Sunnyside Cogeneration Associates

RE: Sunnyside Refuse and Slurry C/007/0035
Request for Phase 1 Bond Release –
Excess Spoil Disposal Area #2 Phase 1 Reclamation

Permittee: SUNNYSIDE COGENERATION ASSOCIATES
Mine: SUNNYSIDE REFUSE & SLURRY **Permit Number:** C/007/035
Title: Excess Spoil Disposal Area #2 Ph 1 Area - Request for Phase 1 bond release

8-2

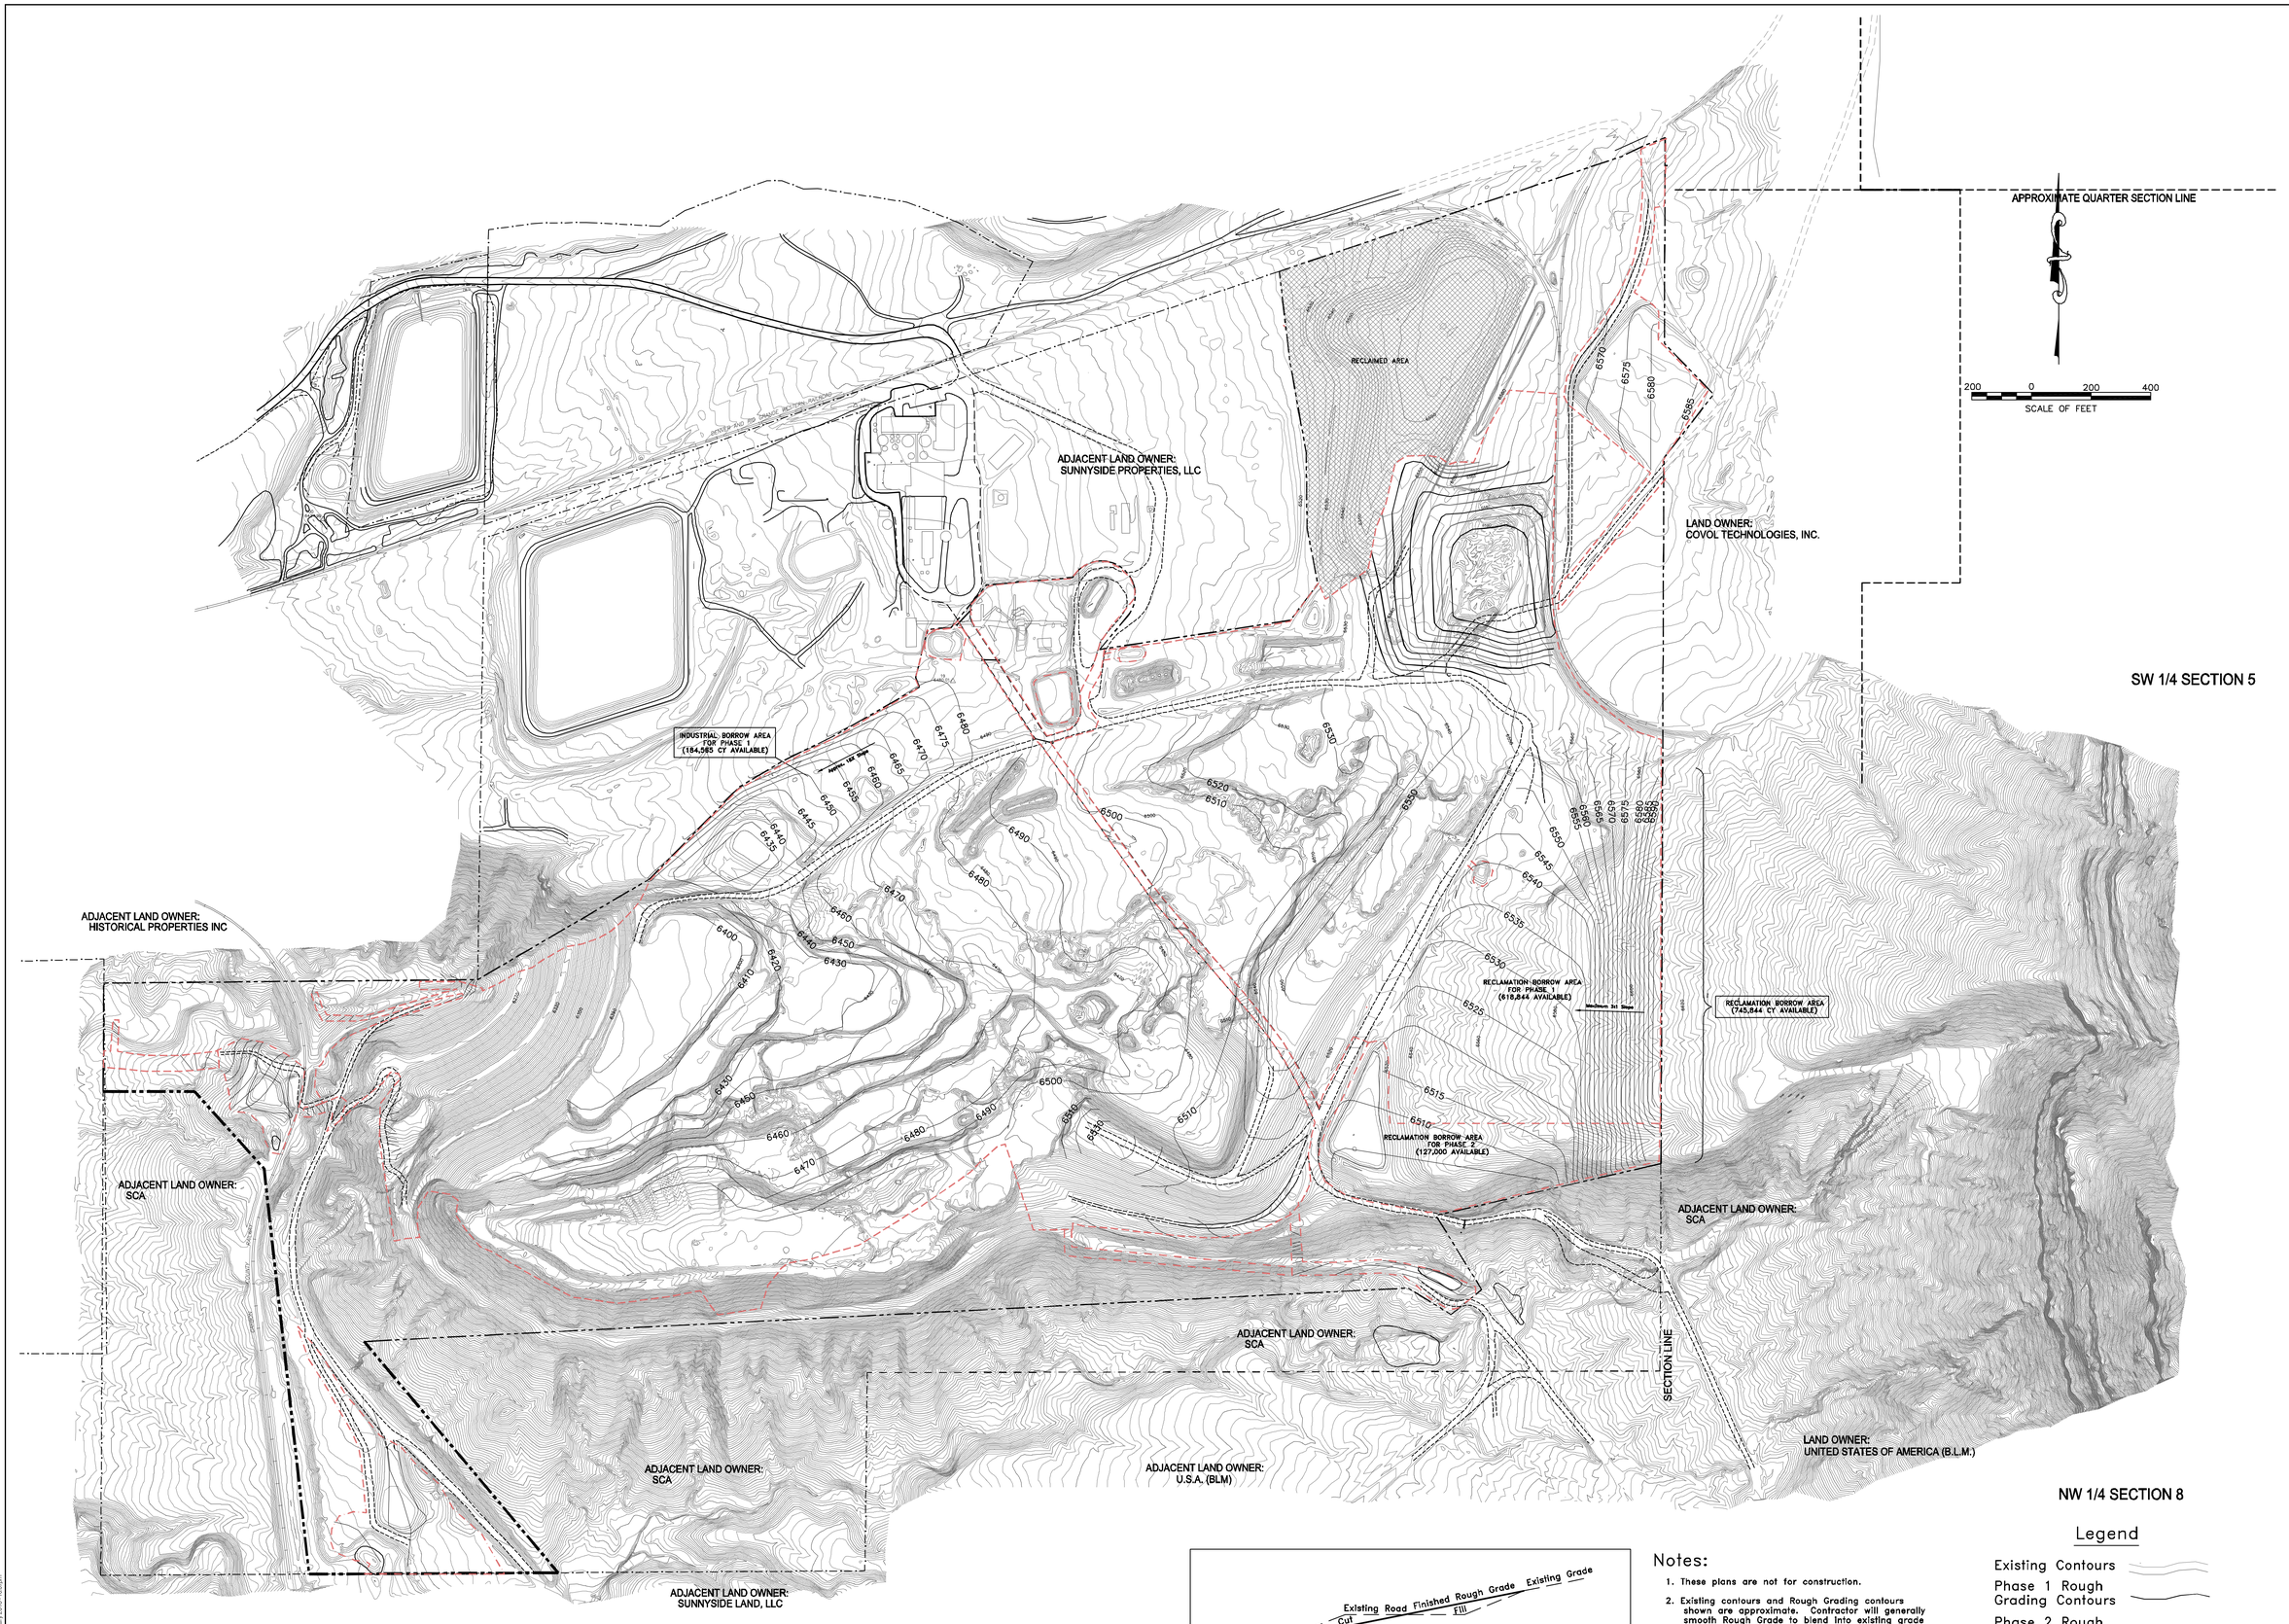
REV.	DATE	DESCRIPTION	BY	APP'D
7	1/16	EXCESS SPOIL DISPOSAL AREA, RECLAMATION UPDATE	AH	
6	11/10	BOUNDARY AND TOPO UPDATES	AH	
5	2/07	UPDATED PASTURE POND	AH	
4	12/05	EXCESS SPOIL #2 GRADING	AH	
3	9/02	2002 PERMIT RENEWAL	AH	
2	9/97	REVISED GRADING	KM	
1	7/94	ADDED COAL PILE AREA	AH

SHEET 8-3 OF

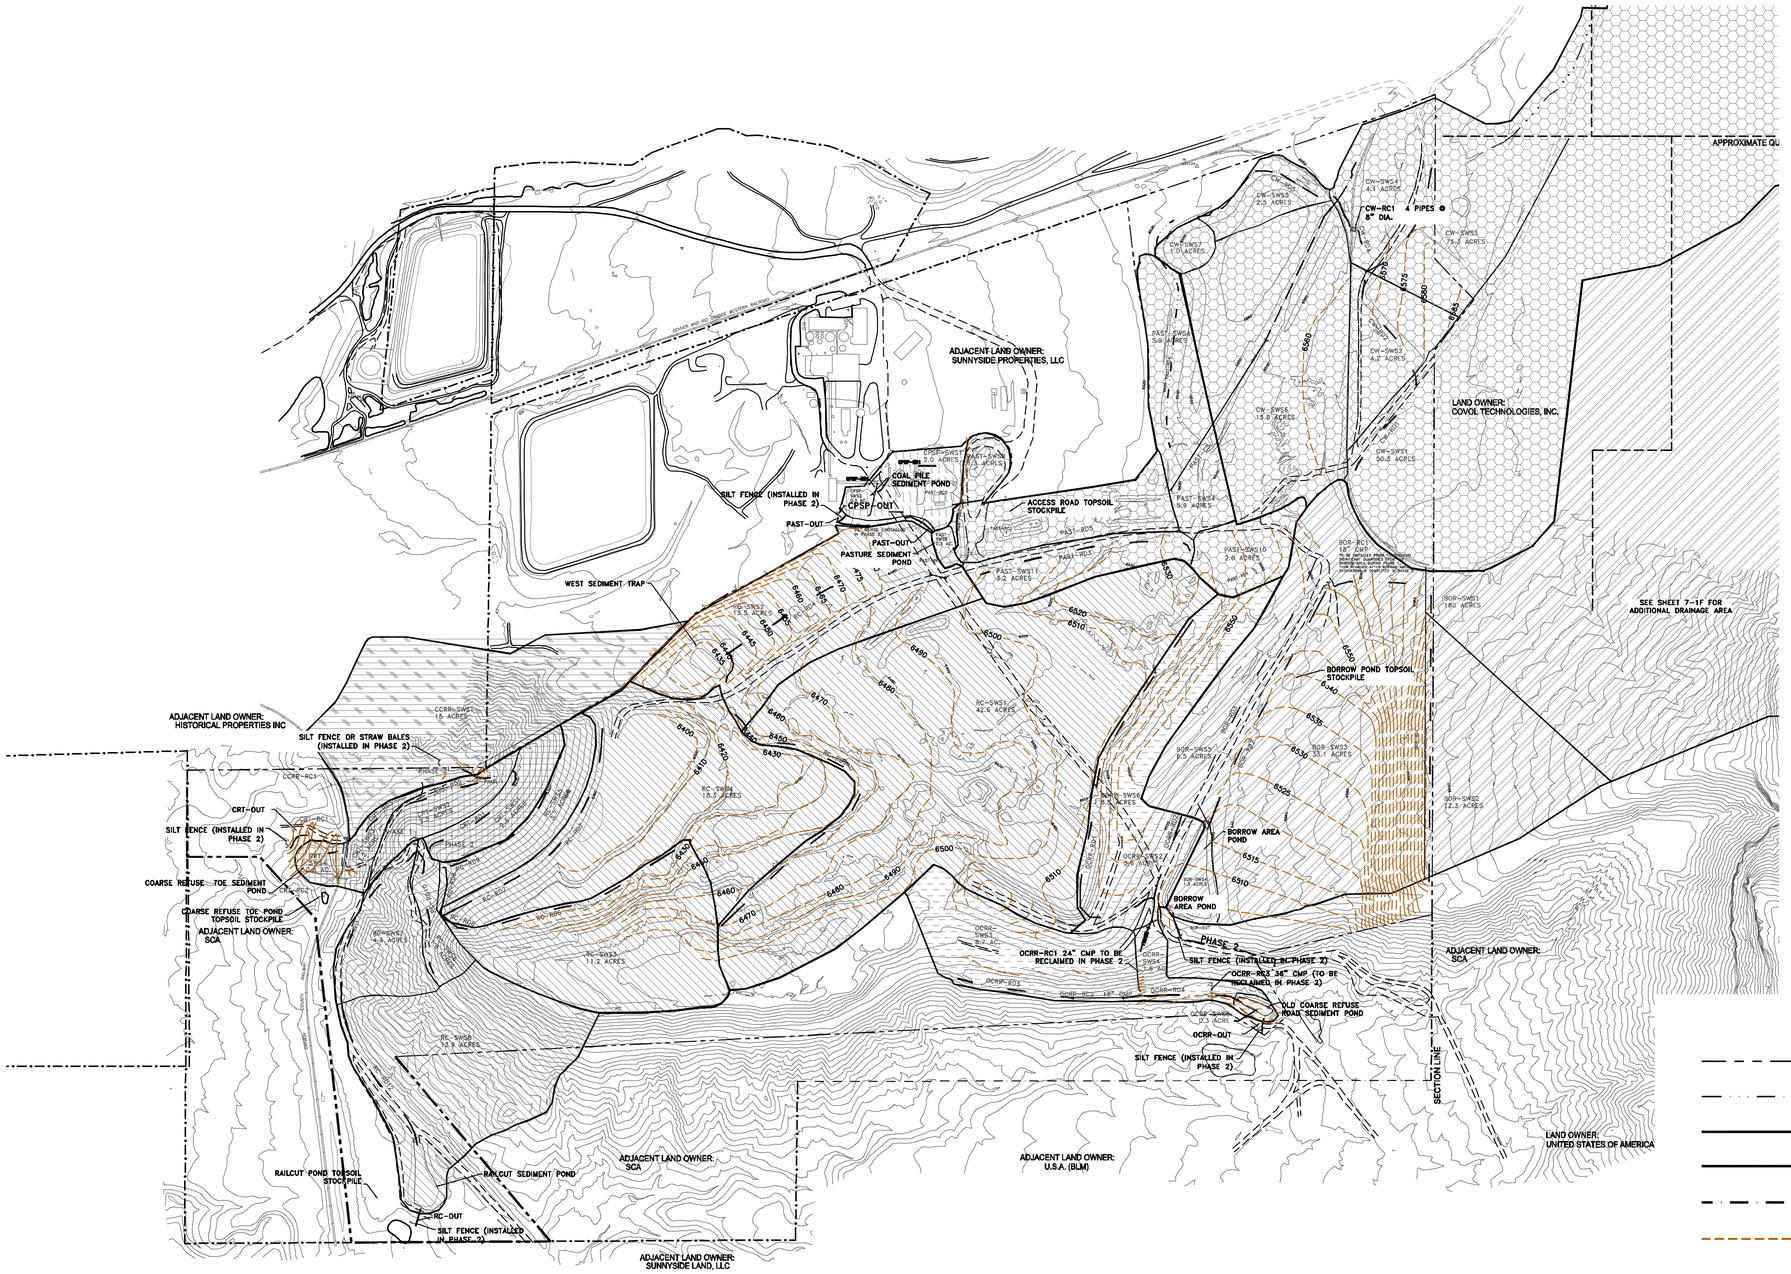
REV	DATE	DESCRIPTION	BY	APP'D
6	1/16	PHASE ONE RECLAMATION UPDATE	AH	
5	11/10	BOUNDARY AND TOPO UPDATE	AH	
4	2/07	PASTURE POND UPDATE	AH	
3	3/06	CLEAR WATER POND RECLASSIFICATION	AH	
2	9/97	PERMIT RENEWAL UPDATES	AH	
1	8/94	ADDED COAL PILE AREA	AH
